Job Name:	1 Henfaes Road, Tonna, Neath Port Talbot, SA11 3DX	Job N ^o :	IMA-24-077
Date:	22 nd June 2026	Client:	Emily Byrne

NEATH PORT TALBOT COUNTY BOROUGH COUNCIL
ENGINEERING & TRANSPORT - ACTIVE TRAVEL OBSERVATIONS

Planning Application No: P2024/0818

IMA Designer's Response to Active Travel Observations

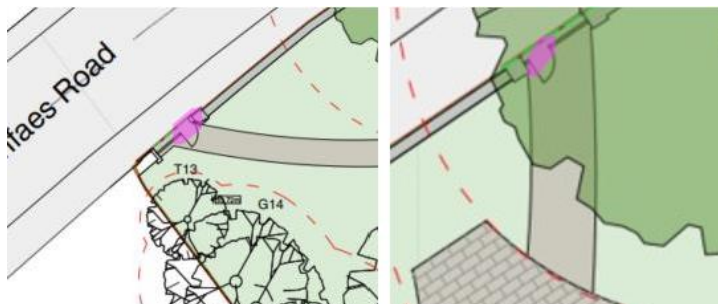
- 4.1 *Please confirm that the widths of all the footway/footpaths within the site meet ATAG standards (DE101 p324/ DE102 p327).*

All footways within the site are 2m wide in accordance with ATAG standards.
